Access Compliance Report Public Rights-of-Way (Curb Ramps)

Main Street: N ALEXANDER ST Location: Intersection ID: 12450 Cross Street: E 9TH ST N Ramp Type: Combination2Diag Initial Pass/Fail: Fail **Overall Compliance: No** 0 ADA ID: A6DBED9483A4 **Severity Score:**

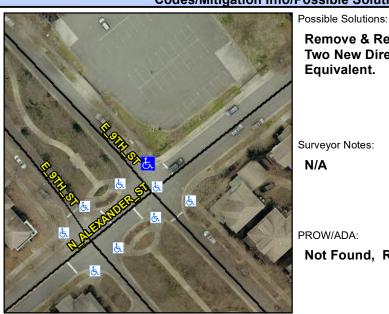
Not Found, R304.5.1, R304.5.1

Compliance Description		Data	Comp	liance Description
N/A	Ramp Length LT (in)	69.0	N/A	Ramp Length RT (in)
No	Ramp Width LT (in)	33.0	N/A	Ramp Width RT (in)
Yes	Ramp Slope LT (%)	5.8	N/A	Ramp Slope RT (%)
Yes	Ramp XSlope LT (%)	0.1	N/A	Ramp XSlope RT (%)
N/A	Ramp Length (in)	26.0	Yes	Ramp Slope (%)
No	Ramp Width (in)	45.0	Yes	Ramp XSlope (%)
N/A	Flare Type LT	N/A	N/A	Flare Type RT
N/A	Flare Slope LT (%)	N/A	N/A	Flare Slope RT (%)
N/A	Flare Traversable LT?	N/A	N/A	Flare Traversable RT?
N/A	Landing Length (in)	N/A	N/A	DWS Provided?
N/A	Landing Width (in)	N/A	N/A	DWS Contrast?
N/A	Landing Slope (%)	N/A	N/A	DWS Length (in)
N/A	Landing X Slope (%)	N/A	N/A	DWS Full Width?
N/A	Landing Curb? (Y/N)	N/A	N/A	DWS Offset (in)
N/A	Shared Landing?	N/A		
N/A	Gutter Ponding?	N/A	N/A	Gutter Slope (%)
N/A	Gutter Lip Ht (in)	N/A	N/A	Gutter X Slope (%)
N/A	Painted X Walk1?	No	N/A	Painted X Walk2?
	X Walk 1 Direction	To SW		X Walk 2 Direction

Street 1 Name StopSign Stop Condition-Street 1 Street 2 Name Stop Condition-Street 2 N ALEXANDER ST Remove & Replace Curb Ramp With Two New Directional Ramps or Equivalent.
